**HAZARD IDENTIFICATION FOR THE GEOLOGIC  
REPOSITORY OPERATIONS AREA:  
A PROGRESS REPORT**

**U.S. Nuclear Regulatory Commission  
Contract NRC-02-97-009**

**Center for Nuclear Waste Regulatory Analyses  
San Antonio, Texas**

**August 2002**

Figure 3-1 (a). Fault Tree Handling Equipment (Yoke-Drop) from Overhead Cranes

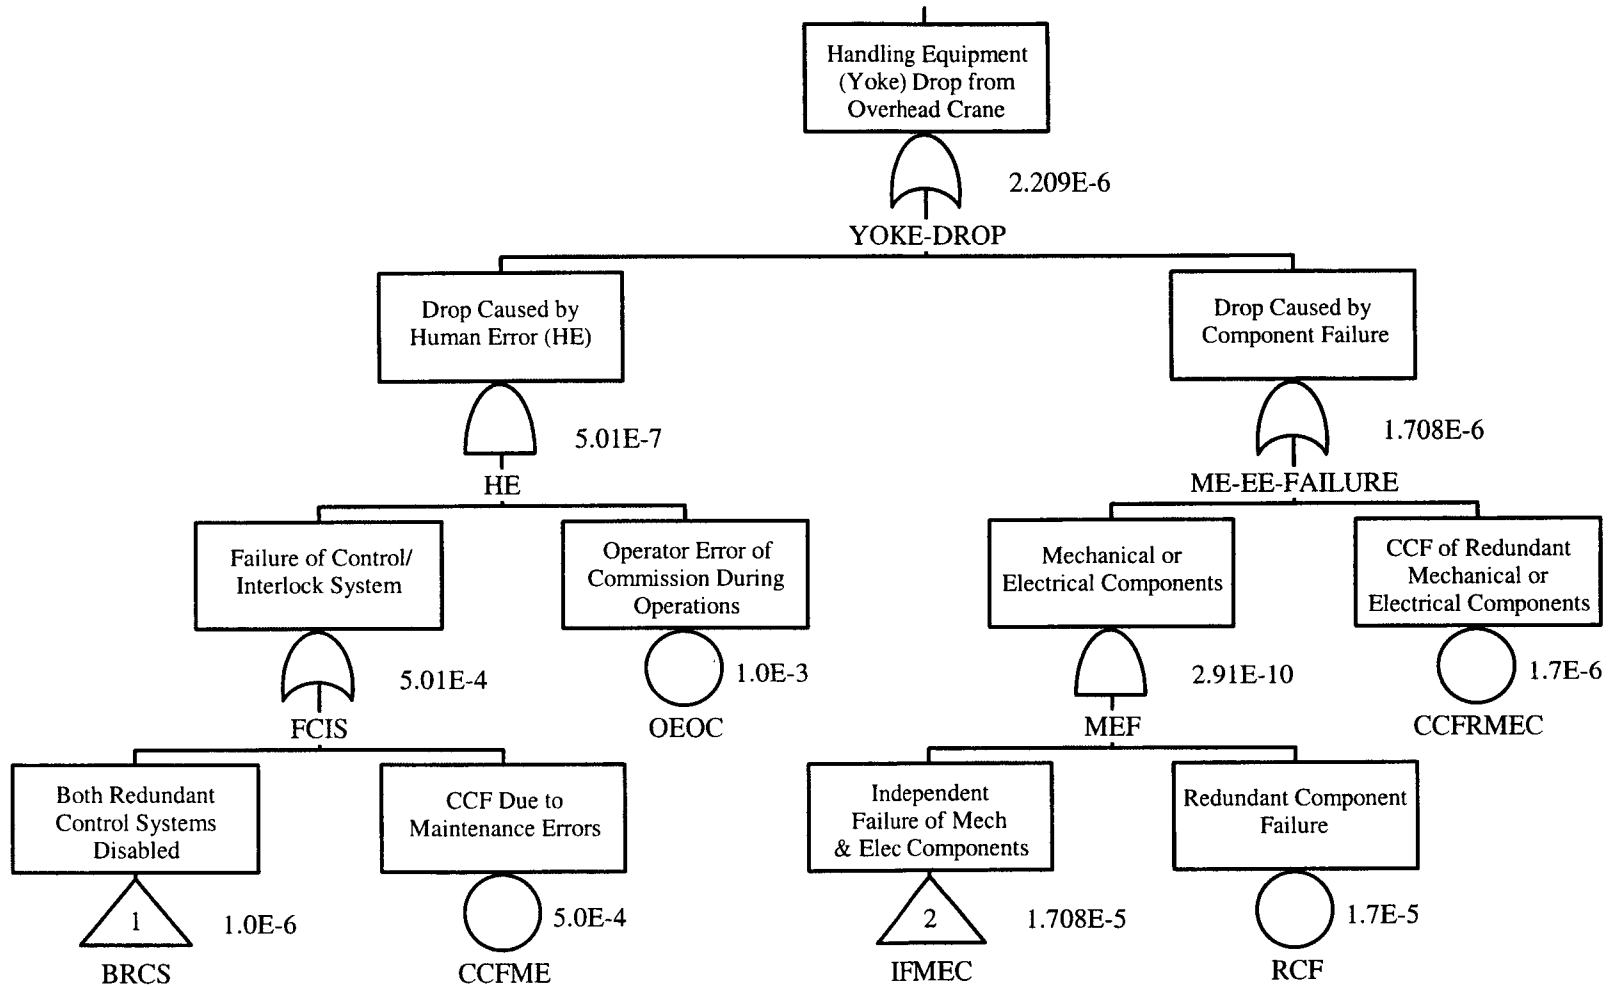
Level of Detail: The basic events for human error are failure to follow written procedures during maintenance and checker failure to detect error during maintenance. The maintenance procedure for the crane is likely to be composed of several tasks, rather than one. If the entire sequence were considered, there may be many steps that could disable the crane. A full analysis that considered several possibilities for disabling the crane during maintenance, as well as recovery from them, might lead to a higher (or perhaps lower) basic failure rate. In other words, the failure rate assumed (0.01) may be more reflective of a single task performed according to written instructions (Swain and Guttman, 1983, Table 20-6, line 1), rather than the entire maintenance sequence. In the same Table 20-6, line 7 provides a much higher human error probability (0.3) for "use written maintenance procedures." Use of this higher value would have a substantial effect on the overall probability of the top event. This fault tree may have been trimmed at too high a level to determine with sufficient precision the probability of disabling the crane from a maintenance procedure. A more detailed fault tree that evaluates the entire maintenance procedure may be needed. Alternatively, rather than using generic error rates, if the error rate for crane maintenance is known, that could be used.

The failure of mechanical and electrical components has been considered in the fault tree analysis (CRWMS M&O, 2000c, Figure 1). Independent failure of active components such as cable, hoisting drum, brake clutch, and control system was considered. It appears that a composite failure rate determined by the union of failure rates of all the components was used in the analysis (CRWMS M&O, 2000c). A generic crane system consists of additional mechanical and electrical components, (e.g., hook, gearbox, gearbox/brake shaft,

gearbox/coupling, motor) (Duke, 1985). Failure of these components may alter the failure probability of the top event. A more detailed fault tree modeling of components and systems needs to be considered.

Estimation of Probability: The fault tree accompanying this commentary is an example of how an alternative set of assumptions and failure rates can lead to a substantial difference in probability for this event initiator. The fault tree and accompanying commentary are based on a preliminary, limited review and are not intended to be definitive or final. The concerns raised are intended to be illustrations of the type of considerations DOE should make in moving toward a complete preclosure safety analysis to be included in any license application. The DOE fault tree (CRWMS M&O, 2000c, Figure 1) was revised based on the previously suggested modifications, and a scoping fault tree analysis was conducted using SAPHIRE Version 6.70 software. The fault tree structure using SAPHIRE Version 6.70 is shown in Figure 3-1(a-g). As discussed previously, higher dependency ( $\beta = 0.5$ ) was assumed for the common cause failure caused by maintenance errors. Failure of the mechanical and electrical components was modeled after the hoist failure logic diagram (Duke, 1985). The mechanical failure of a crane
